STAFF REPORT

RE: 700 Truman Avenue (Landscape Sec 108 Review)

FROM: Karen DeMaria, City of Key West Urban Forestry Manager KAD

LANDSCAPE PLAN FOR DEVELOPMENT & TREE COMMISSION APPROVAL

TC-01 PLANTING PLAN
 Scale: 1" = 20'-0"

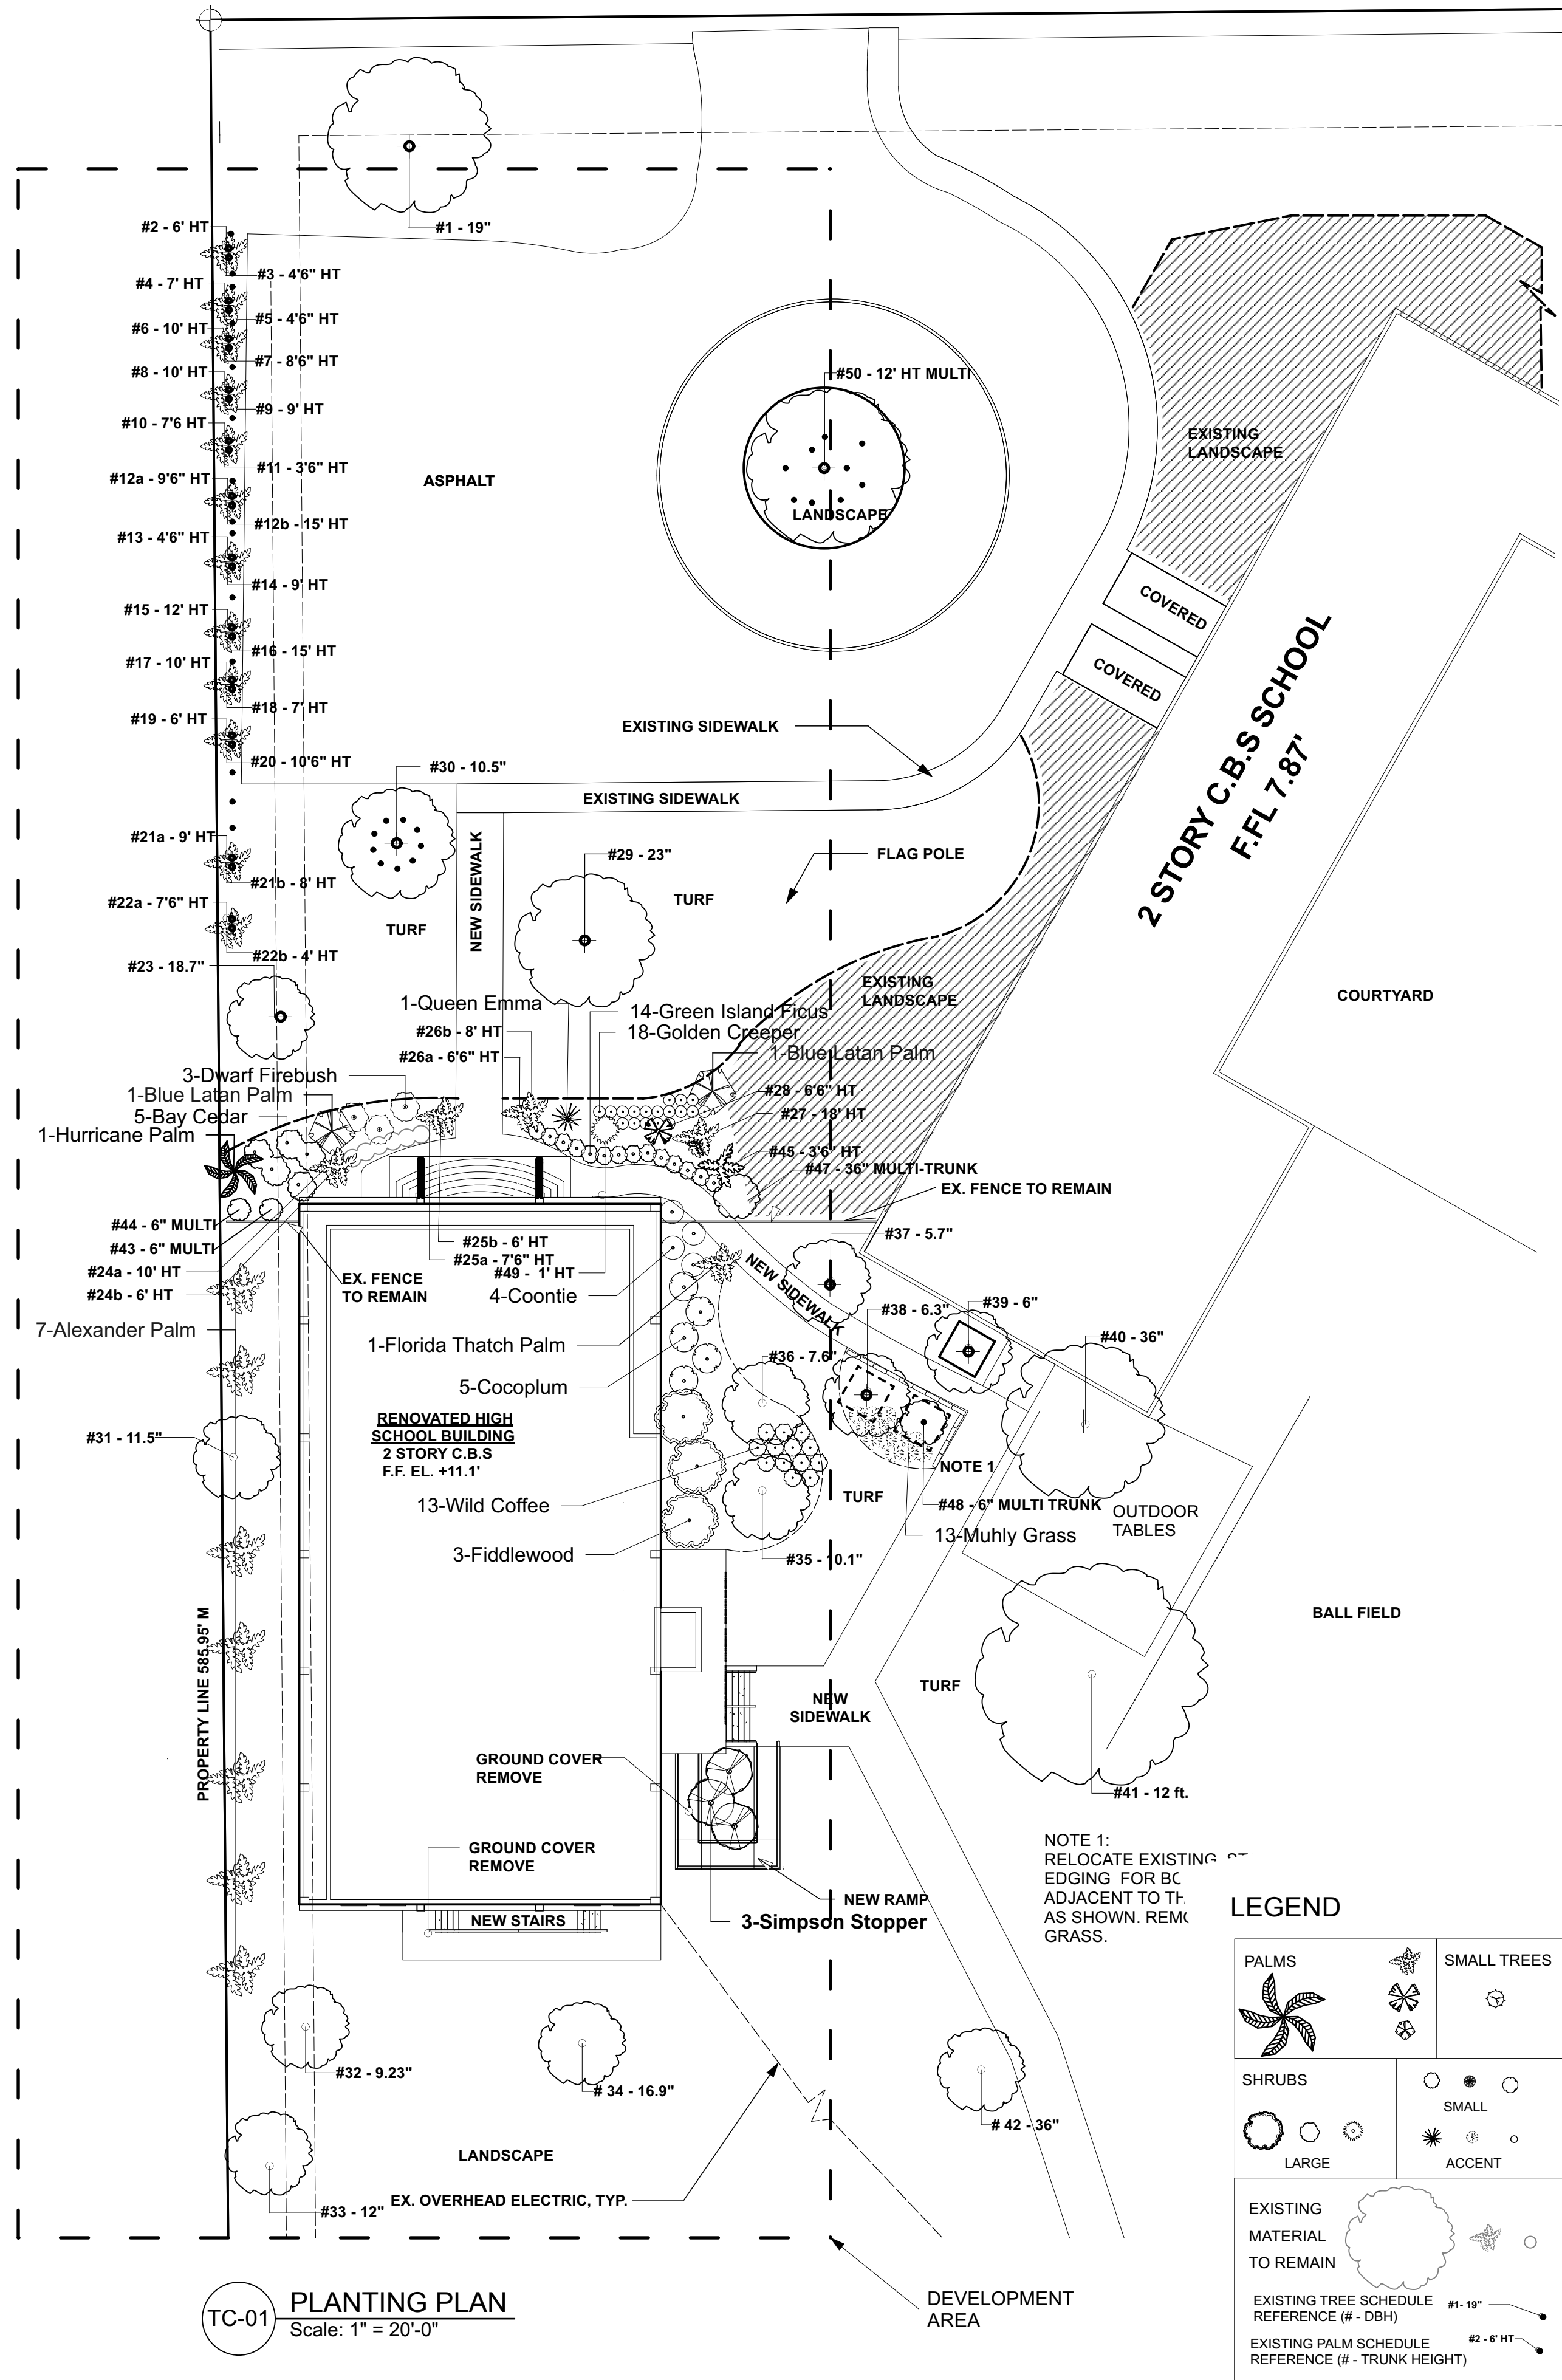
Around the actual proposed development project area there is a parking lot to the north, school open field area to the east and south, and single family residential area to the west. The landscape plan proposes to add (7) Alexander Palms to this western property line area and there is an existing Royal Poinciana tree, an existing Gumbo Limbo tree, and numerous existing thatch palms in this area for a total of 135 plant units.

12. Sec 108-447: The landscape plan does include a tree protection plan.
13. Sec 108-515: A formal irrigation plan has not been submitted. A note on the landscape plans indicates that the existing irrigation system will be modified to provide coverage for this area.

I had a meeting with Bill Horn about this a few weeks ago. I would look at the immediate area surrounding the auditorium for the review, the impact area of the proposed development and staging. Of primary interest are the existing trees around that area and some proposed buffer landscaping with the adjoining neighbors.
 Sincerely,
 Karen

THE PROPOSED DEVELOPMENT IS TO AN EXISTING BUILDING LOCATED ON THE BASILICA OF KEY WEST CAMPUS. THIS SITE IS HEAVILY VEGETATED WITH MANY SPECIMEN TREES AND PALMS. THE RENOVATION TO THE EXISTING AUDITORIUM WILL NOT IMPACT ANY EXISTING TREES OR PALMS. TREE PROTECTION ZONES SHALL BE INSTALLED, FOUNDATION PLANTINGS ADDED AND SCREENING INSTALLED ON THE NW BOUNDARY AS SHOWN PER THE CITY URBAN FORESTRY MANAGER' DIRECTION.

THERE IS AN EXISTING IRRIGATION SYSTEM IN THE DEVELOPMENT AREA. THE SYSTEM CONSISTS OF TURF HEADS AND POP UP RISERS. EXPANSION OF THE EXISTING IRRIGATION SYSTEM SHALL BE INSTALLED AS NECESSARY DURING INSTALLATION. ALL LANDSCAPE MAINTENANCE IS PREFORMED BY STAFF DIRECTLY EMPLOYED BY ST. MARY'S, UNDER THE DIRECTION OF THE HEAD GROUNDSKEEPER, MR. PAUL WALTERSON. NEW PLANTINGS SHALL BE WATERED BY HAND DURING THE ESTABLISHMENT PERIOD.

SCREENING REQUESTED BY THE CITY URBAN FORESTRY MANAGER ON THE NW BOUNDARY SHALL BE NON-INVASIVE, NON-NATIVE PALMS DUE TO THE LIMITED PLANTING AREA AND THE EXTENSIVE SHADE.

LANDSCAPE PLAN FOR DEVELOPMENT & TREE COMMISSION APPROVAL

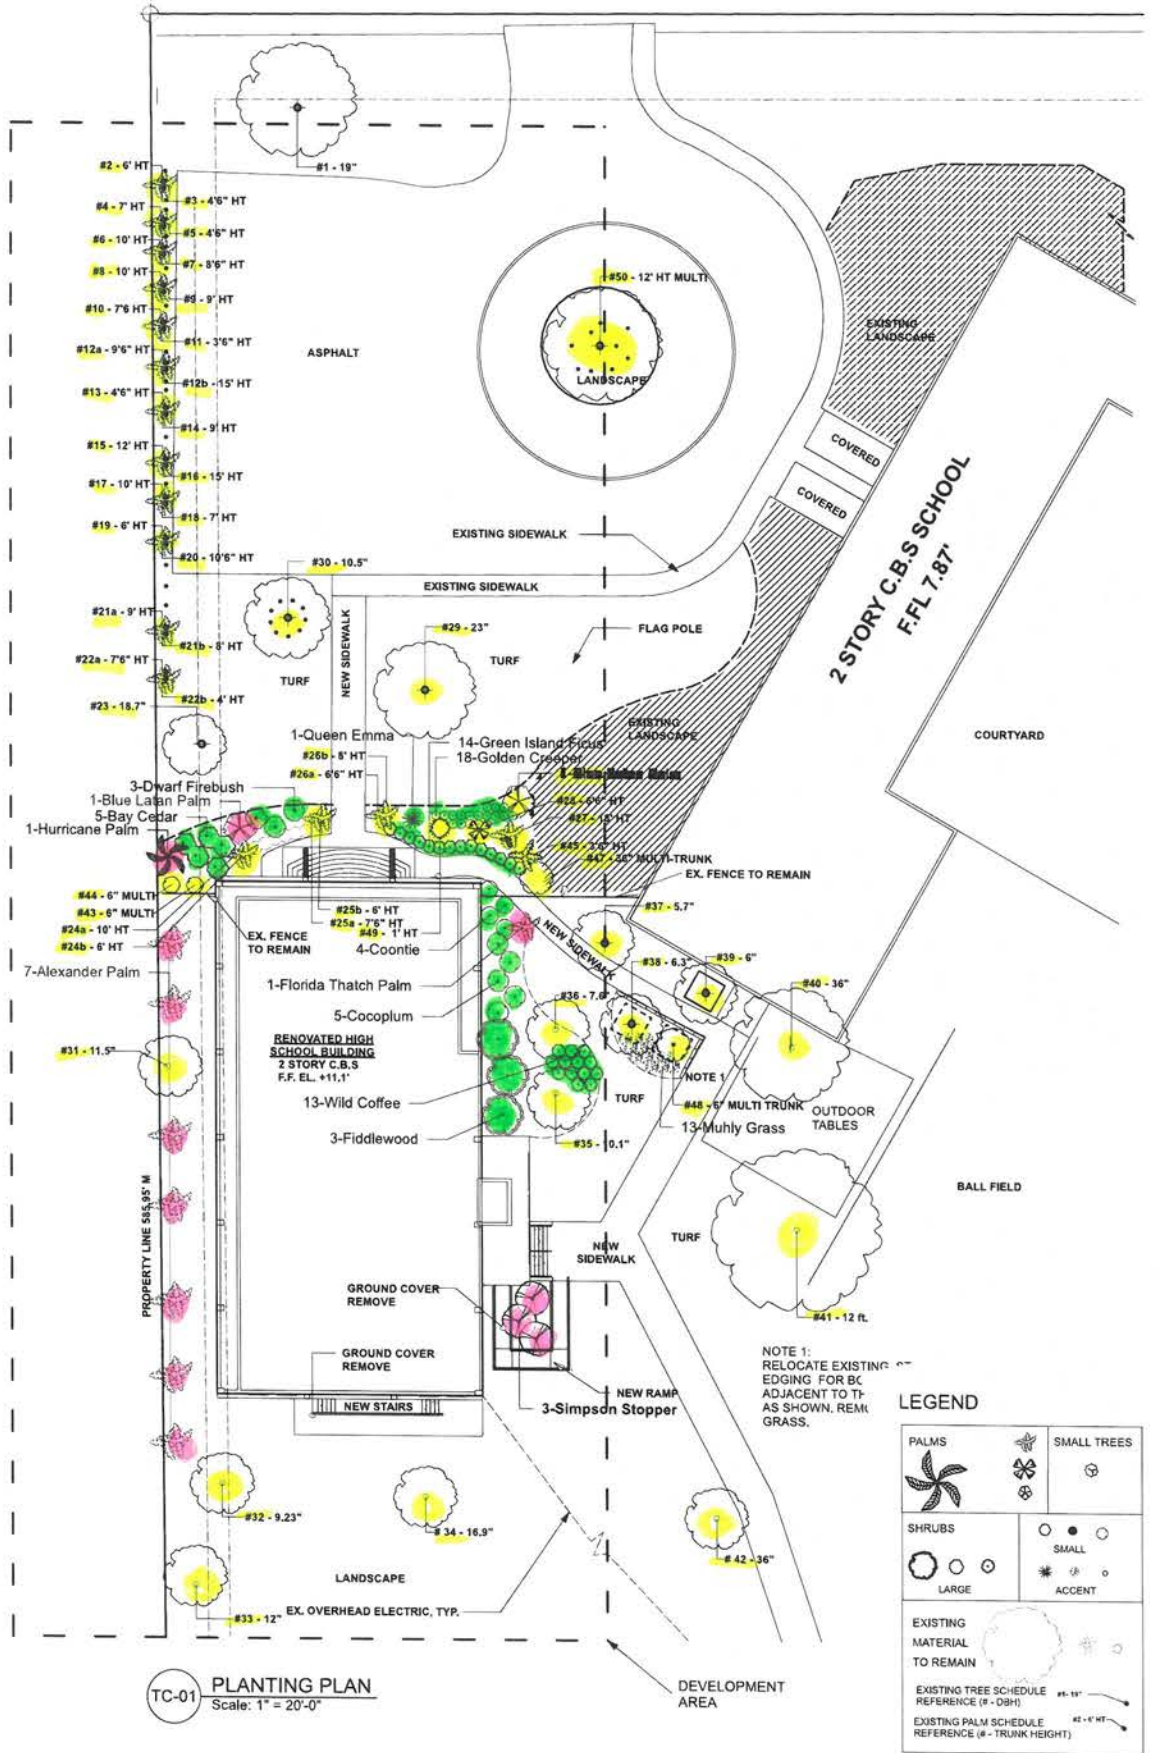
The Conceptual Landscape Plan list indicates at least 70% native vegetation proposed to be used in the new landscaping that will enhance the immediate work area. A preliminary plan was submitted with the file but the plan does not identify exactly what vegetation will be planted where. Additional information has been requested to include the submittal of a completed landscape plan.

I had a meeting with Bill Horn about this a few weeks ago. I would look at the immediate area surrounding the auditorium for the review, the impact area of the proposed development and staging. Of primary interest are the existing trees around that area and some proposed buffer landscaping with the adjoining neighbors.
 Sincerely,
 Karen

THE PROPOSED DEVELOPMENT IS TO AN EXISTING BUILDING LOCATED ON THE BASILICA OF KEY WEST CAMPUS. THIS SITE IS HEAVILY VEGETATED WITH MANY SPECIMEN TREES AND PALMS. THE RENOVATION TO THE EXISTING AUDITORIUM WILL NOT IMPACT ANY EXISTING TREES OR PALMS. TREE PROTECTION ZONES SHALL BE INSTALLED, FOUNDATION PLANTINGS ADDED AND SCREENING INSTALLED ON THE NW BOUNDARY AS SHOWN PER THE CITY URBAN FORESTRY MANAGER' DIRECTION.

IRRIGATION:
 THERE IS AN EXISTING IRRIGATION SYSTEM IN THE DEVELOPMENT AREA. THE SYSTEM CONSISTS OF TURF HEADS AND POPUP RISERS. EXPANSION OF THE EXISTING IRRIGATION SYSTEM SHALL BE INSTALLED AS NECESSARY DURING INSTALLATION. ALL LANDSCAPE MAINTENANCE IS PERFORMED BY STAFF DIRECTLY EMPLOYED BY ST. MARY'S. UNDER THE DIRECTION OF THE HEAD GROUNDSKEEPER, MR. PAUL WALTERSON. NEW PLANTINGS SHALL BE WATERED BY HAND DURING THE ESTABLISHMENT PERIOD.

SCREENING:
 SCREENING REQUESTED BY THE CITY URBAN FORESTRY MANAGER ON THE NW BOUNDARY SHALL BE NON-INVASIVE, NON-NATIVE PALMS DUE TO THE LIMITED PLANTING AREA AND THE EXTENSIVE SHADE.
